SA 316/319

SERVICE BULLETIN

MANDATORY No. 05.84

Monitoring of Horizontal Stabilizer Spar Tubes.

FIGURE 1

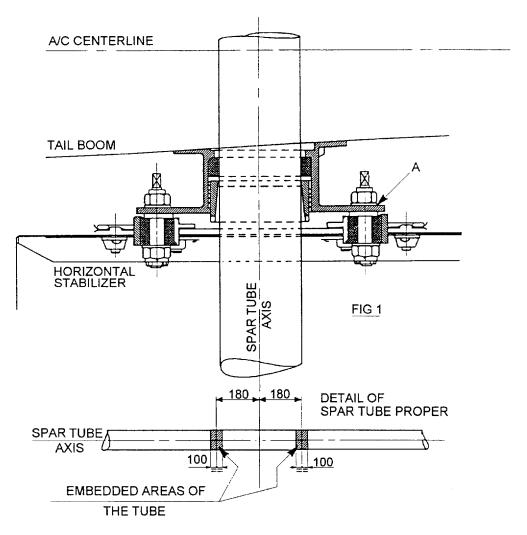
3) Areas to be checked (Figure 1)

The whole tube and in particular the embedded portions on either side of left-hand and right-hand fittings (A), and on the periphery of the tube (Figure 1 - DETAIL).
